7 March 2025

Our ref: 25020070_L01_V04.docx

Development Modification for Penrith Lakes – Response to Agency Queries

Figure 3-1 Flood Hazard as defined by the Australian Emergency Management Institute (AIDR, 2017)

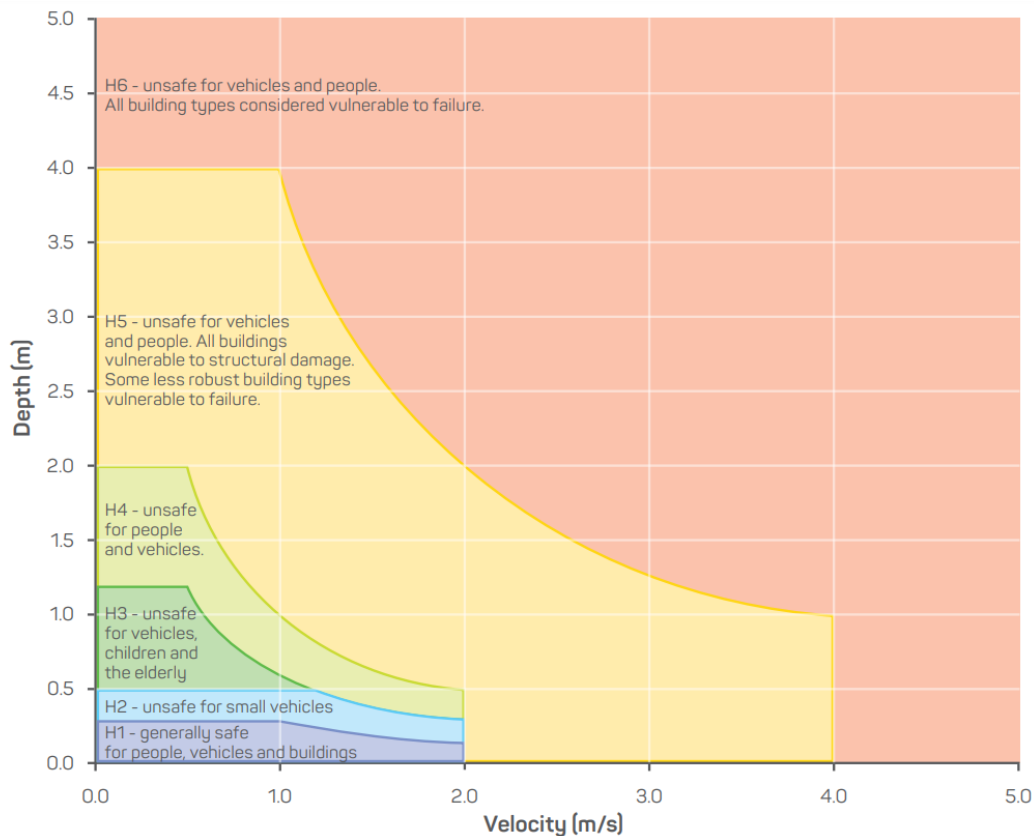
2. *2021 (SEPP WPC) requires the consent authority to be satisfied that the proposal does “not significantly adversely affect flood behaviour in a way that results in detrimental increases in the potential flood affectation of other development or properties” for events up to the PMF. This appears to have not been achieved. The Flood Impact Assessment identifies an increase of 50mm in flood waters on surrounding properties in flood events greater than the 1 in 500 chance per year flood level. Modelling also identifies additional impacts in the smaller events such as the 1 in 200 chance per year flood. As a result, it does not comply with the requirements of Section 5.38 of SEPP WPC. In addition, the already approved fill and resulting landform will displace flood waters onto surrounding properties and should not be further exacerbated.*

An additional assessment of flood hazard has also been undertaken using the model outputs for each of the existing and developed case site conditions and is presented in the plans included in Appendix B. This task was undertaken to provide context with regards to the existing flood hazard within the study area and to confirm that the the import of 9.7 million tonnes of fill does not alter this flood hazard. The hydraulic hazard was categorised based on the flood hazard categories as outlined by Australian Emergency Management Institute (AEMI). The category values range from one (H1) representing for low hazard to six (H6) for the most severe flood hazard as shown in Figure 3-1. A summary of the various hazard categories is included below:

- **H1** – Generally safe for people, vehicles and buildings.
- **H2** – Unsafe for small vehicles.
- **H3** – Unsafe for vehicles, children and the elderly.
- **H4** - Unsafe for people and vehicles
- **H5** - Unsafe for for vehicles and people. All buildings vulnerable to structural damage. Some less robust building types vulnerable to failure
- **H6** – Unsafe for vehicles and people. All building types considered vulnerable to failure.

As shown in the maps presented in Appendix B, the impacts shown in Table 2-1 are located in sections of the floodplain that are already subject to hazard categories H5 and H6 under the existing flood conditions (i.e. before the importation of fill on the site). That is, the maximum impact of up to 34 mm is shown to occur on properties that contain buildings that are already significantly vulnerable to failure under existing conditions and without the import of fill. These properties are already severely compromised in the existing situation and without considering any development proposal. Plans showing the change in flood hazard are presented in Appendix C.

Figure 4-1 Flood Hazard as defined by the Australian Emergency Management Institute (AIDR, 2017)

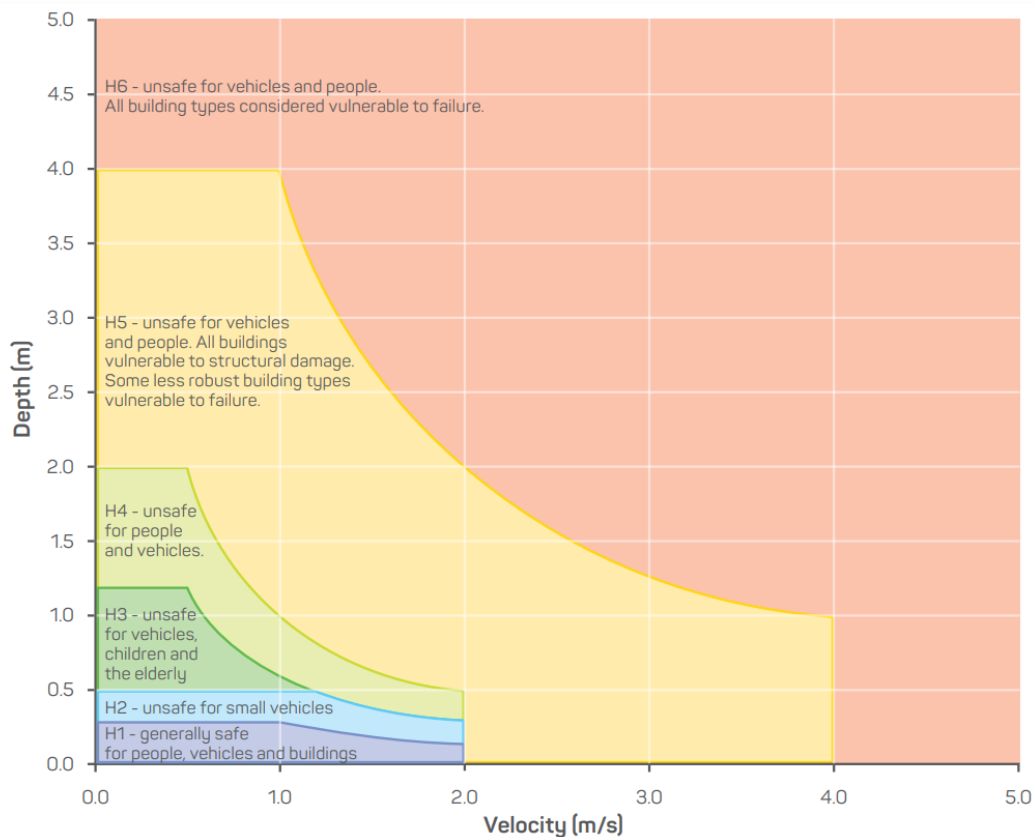
3. *Recommend further modelling is undertaken showing the flood hazard for the site in post development conditions to help better understand the risks to life and property posed by this modification.*

An additional assessment of flood hazard has also been undertaken using the model outputs for each of the existing and developed case site conditions and is presented in the plans included in Appendix B. This task was undertaken to provide context with regards to the existing flood hazard within the study area and to confirm that the import of 9.7 million tonnes of fill does not alter this flood hazard. The hydraulic hazard was categorised based on the flood hazard categories as outlined by Australian Emergency Management Institute (AEMI). The category values range from one (H1) representing for low hazard to six (H6) for the most severe flood hazard as shown in Figure 3-1. A summary of the various hazard categories is included below:

As shown in the maps presented in Appendix B, the impacts shown in Table 2-1 are located in sections of the floodplain that are already subject to hazard categories H5 and H6 under the existing flood conditions (i.e. before the importation of fill on the site). That is, the maximum impact of up to 34 mm is shown to occur on properties that contain buildings that are already significantly vulnerable to failure under existing conditions and without the import of fill. These properties are already severely compromised in the existing situation and without considering any development proposal. Plans showing the change in flood hazard are presented in Appendix C.

The flood hazard mapping presented in Appendix C shows that there is no change in hazard category under post-developed conditions and, as such, there is no change to the risks to life and property caused by the modification. As such, there is no requirement for further modelling, noting that an assessment of every design flood event up to and including the PMF has been undertaken. Additionally, further modelling is not required as this application does not seek to change any activity on the land as a result of the approval of the modification. This advice is following previous advice from DPHI to ensure the site is more flood resilient.

Figure 5-1 Change in Water Level in HCC LGA – 0.05% AEP (1 in 2,000) Design Flood Event

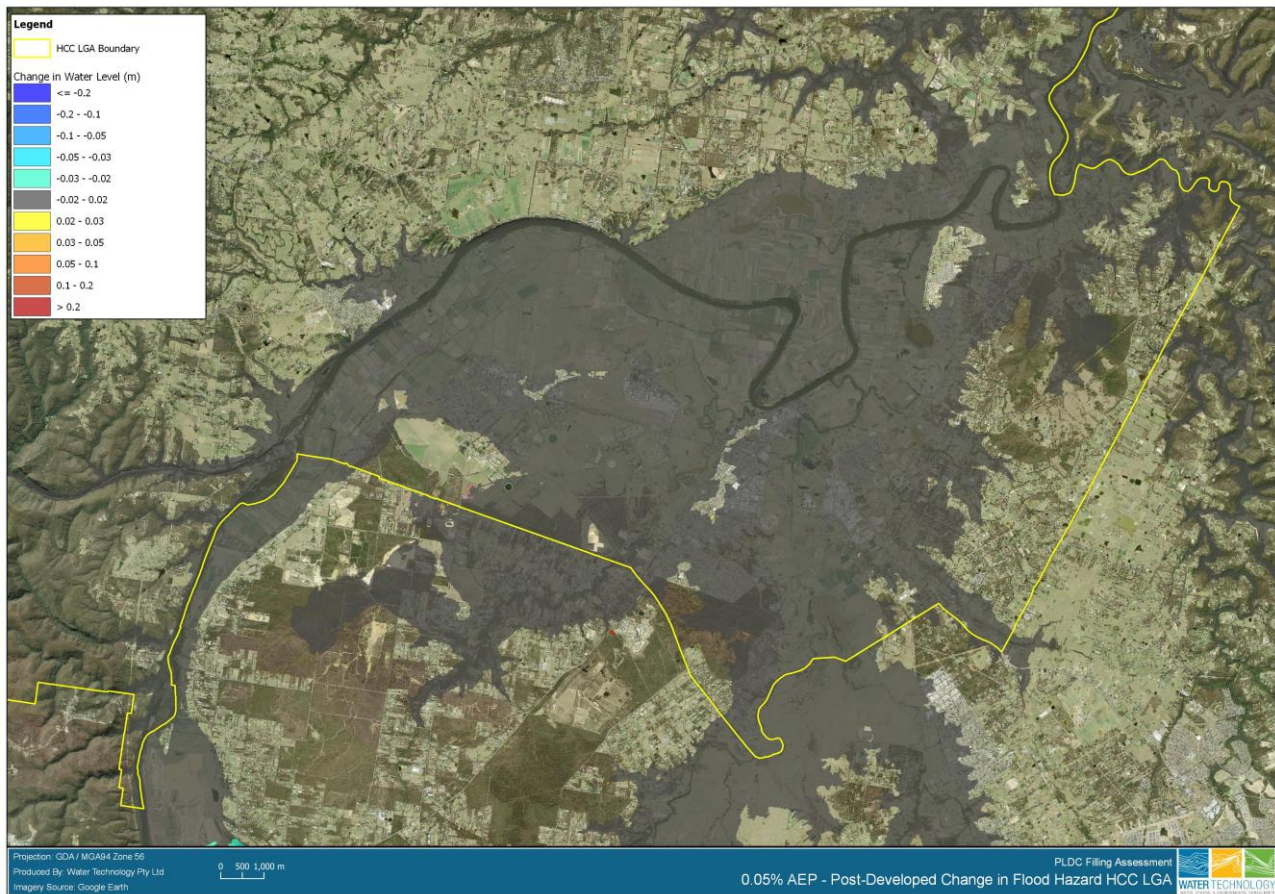
2. *The Flood Impact Assessment states that there is no fundamental change to flooding behaviour in the wider Nepean River Floodplain, however the impacts further downstream into the Hawkesbury Local Government Area have not been demonstrated. The impacts on flood levels, velocities or evacuation capability (including consideration of the outcomes of the NSW State Governments Flood Evacuation Modelling) within the Hawkesbury have not been quantified.*

It was outlined in Section 5 of the submitted WT 2024 report that the flood impacts were fully contained to an isolated region of the floodplain located immediately adjacent to where fill is proposed to be placed. The mapping produced in Appendix D of WT 2024 and Appendix A of this response confirm this. However, for the purposes of clarity in this response and to otherwise better illustrate the results specifically to HCC, Figure 5-1 shows the change in water level in the critical design flood event for the 0.05% AEP (1 in 2,000) event in the downstream HCC Local Government Area (LGA). The 0.05% AEP (1 in 2,000) is represented in this figure as the largest increases in water level occur during this design flood event.

It is evident from Figure 5-1 that the import of fill does not result in impacts within the HCC LGA greater than 20mm, nor does it impact existing evacuation capability with the HCC LGA, noting that any minor increase in water level of possibly, particularly in extreme flood events, is not likely to result in a change in road flood immunity or hazard. The flood impacts that are estimated to occur, which have already been prescriptively documented in Section 5 of the submitted WT 2024 report and further clarified in Section 2.2 of this letter, are located in close proximity to the immediate PLDC site, occur only in very rare flood events and additionally only occur in areas that are already subject to significant flood depths and flood hazard. Increases were found to occur in events smaller than the 0.1% AEP (1 in 1,000) but these are less than 20mm.

PLDC Filling Assessment
0.1% AEP - Post-Developed Change in Water Level

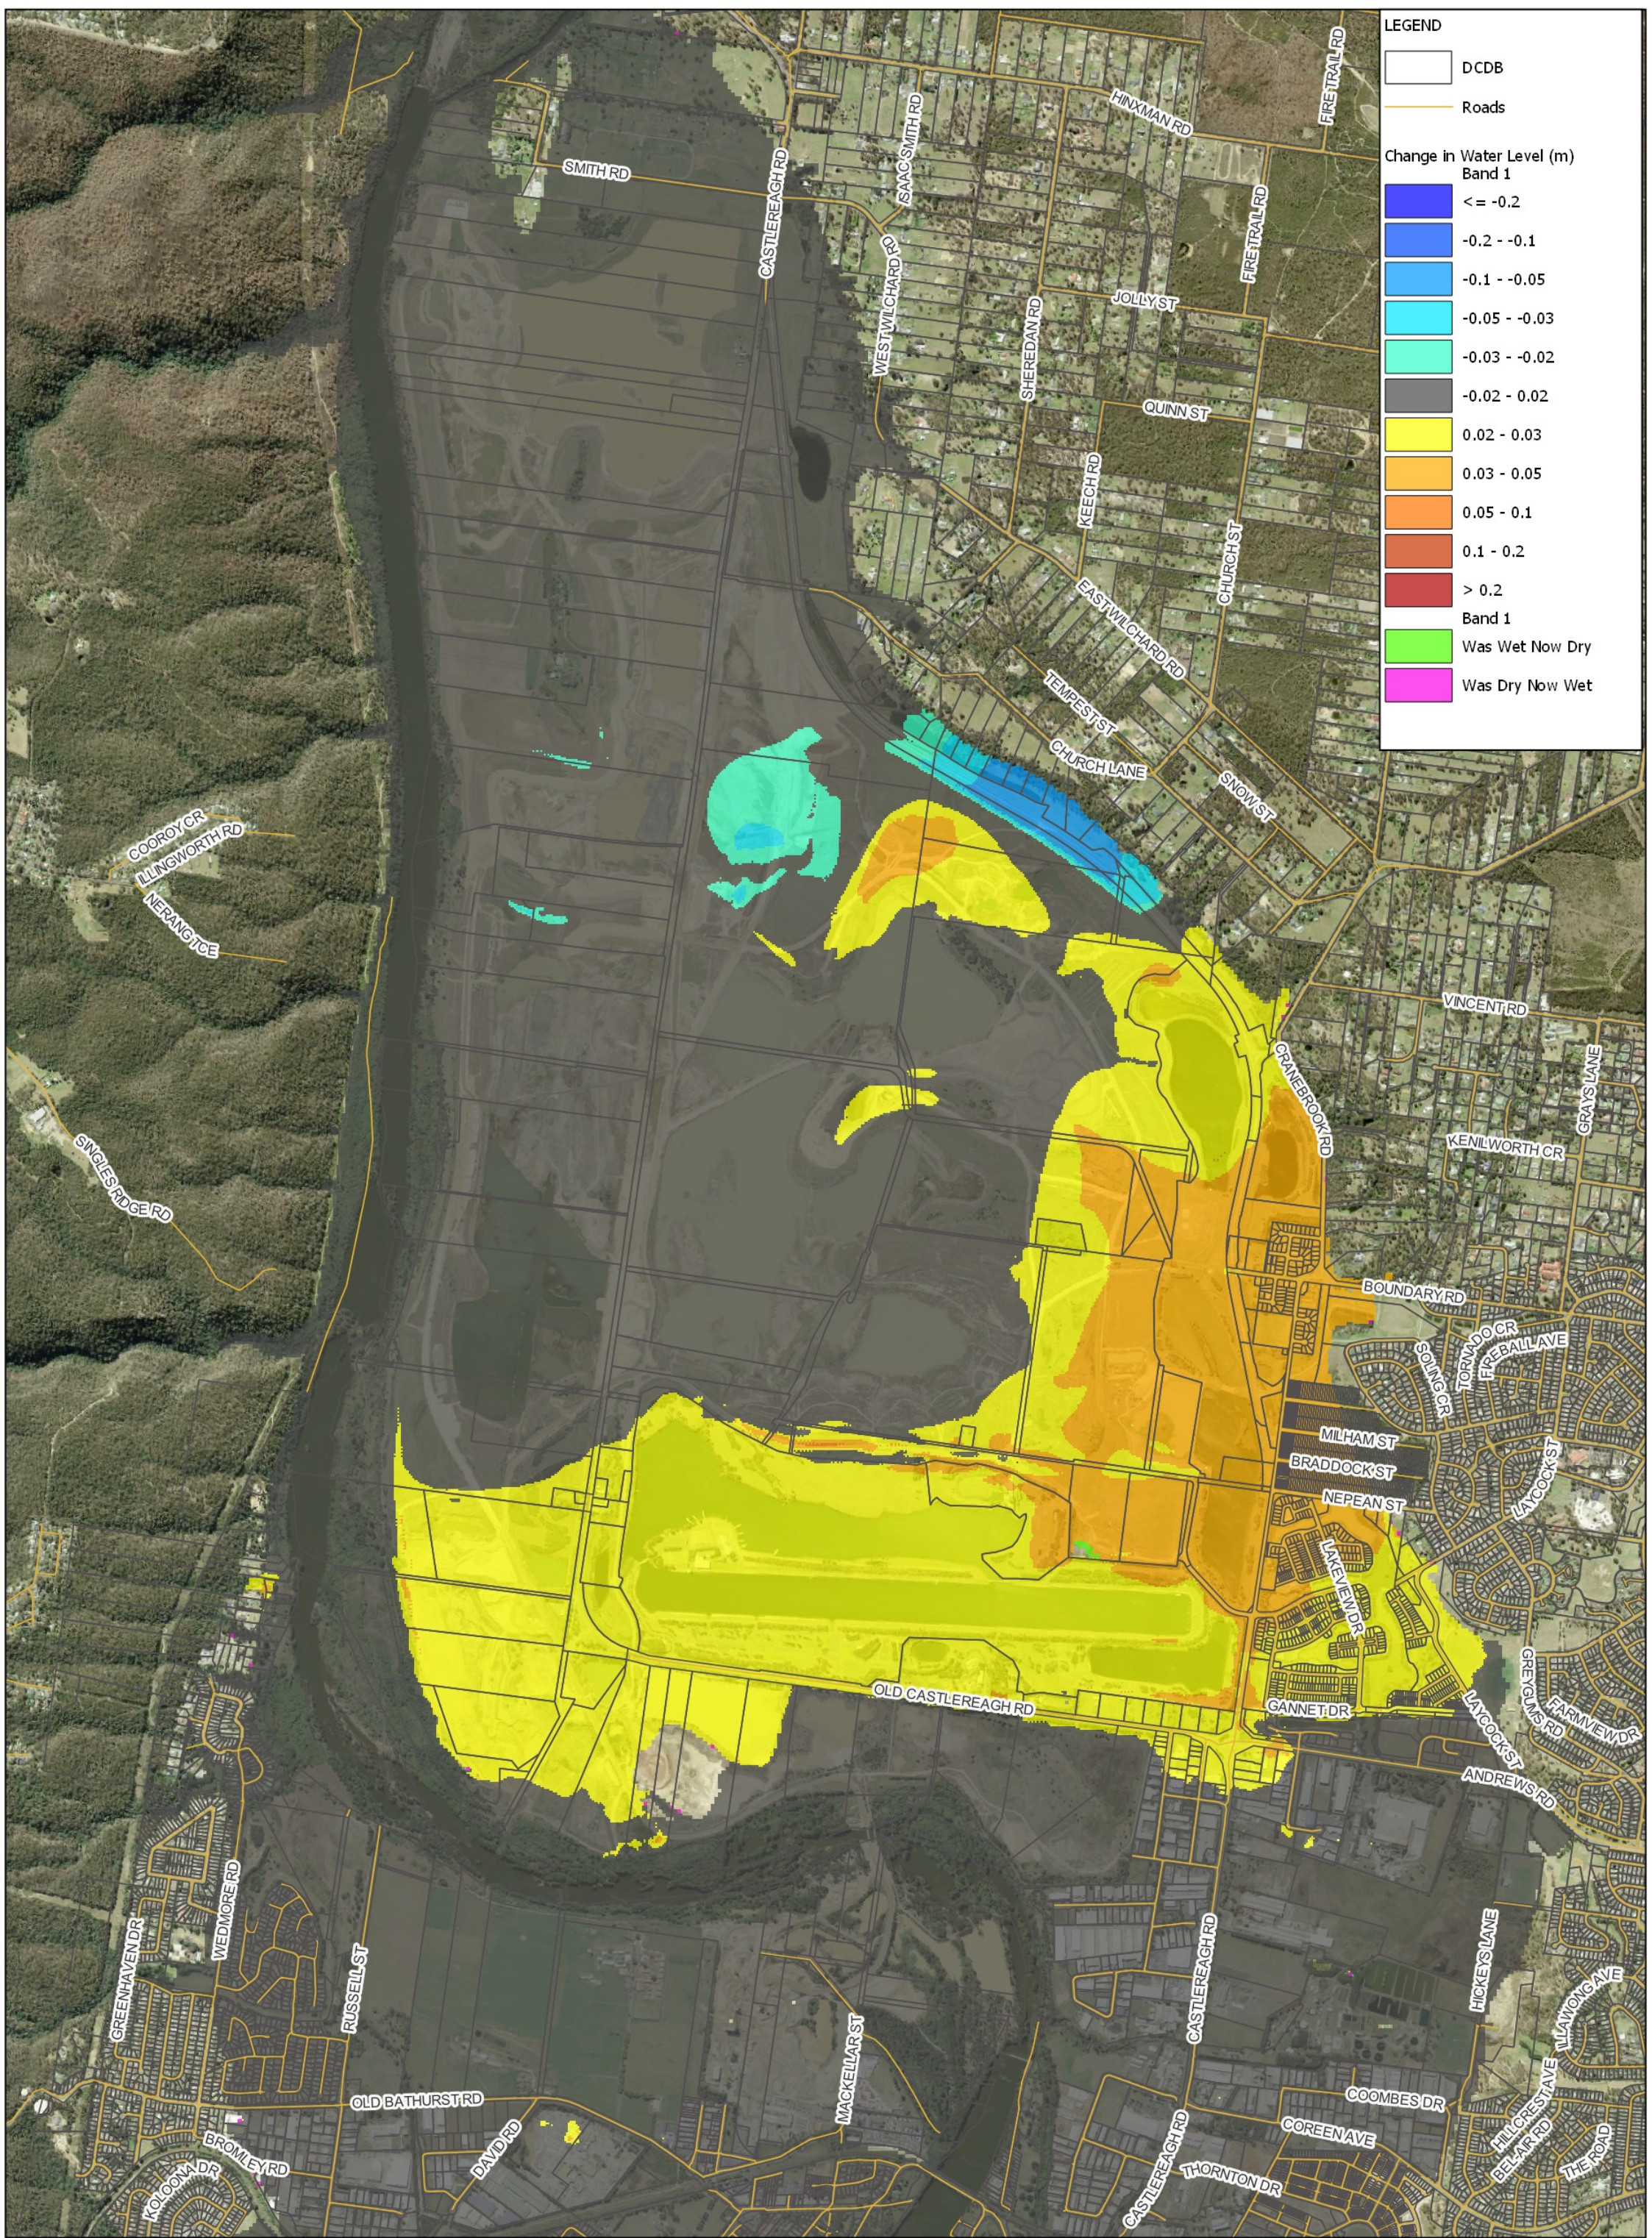
1. *The submitted Flood Impact Assessment (FIA) identifies a maximum increase of 50mm in flood impacts as a result of the fill and has identified the land that was previously dry and would not be wet as a result of this modification. However, the FIA has not identified properties that were previously inundated and*

would now be subject to increased flood waters. The Department requires the identification of properties where the flood waters would increase as a result of the development and an assessment of the change of impact as a result of this modification.

- Section 5 and Appendix D in WT 2024 includes mapping showing the extent of impacts greater than 20 mm which only occur in the 0.1% AEP (1 in 1,000), 0.05% AEP (1 in 2,000) and the 0.02% AEP (1 in 5,000) design flood events. Maps showing the extent and magnitude of flood impacts as a consequence of the proposed fill are presented in in Appendix A of this response.

- As presented in Table 2-1 and the impact mapping in Appendix A of this response, the import of fill does not result in impacts greater than 10 mm in flood events of a 0.2% AEP (1 in 500) magnitude or less. That is, the increases in water level are negligible in all modelled design flood events up to and including the 0.2% AEP (1 in 500) design flood event. The results outlined in Table 2-1 also show a reduction in peak water level in several locations (shown as a negative impact).

- Similarly, the information presented in Table 2-1 and the impact mapping in Appendix A of this response indicates that there are small, isolated increases in water levels which are mapped within the colour banding range of 20-50mm which do occur on some external properties in the 0.1% AEP (1 in 1,000), 0.05% AEP (1 in 2,000) and the 0.02% AEP (1 in 5,000) design flood events. This is due to the change in floodplain storage and localised decreases in flow conveyance. The largest of these increases is found to be 34 mm which occurs in an area in close proximity to the PLDC site in the 0.05% AEP (1 in 2,000) design flood event. The largest impact in the 0.1% (1 in 1,000) and 0.02% AEP (1 in 5,000) design flood events was found to be 29mm and 26 mm, respectively. Slightly less impacts occur in the 0.02% AEP (1 in 5,000) design flood event due to the increase in floodplain width and flow area across the floodplain.
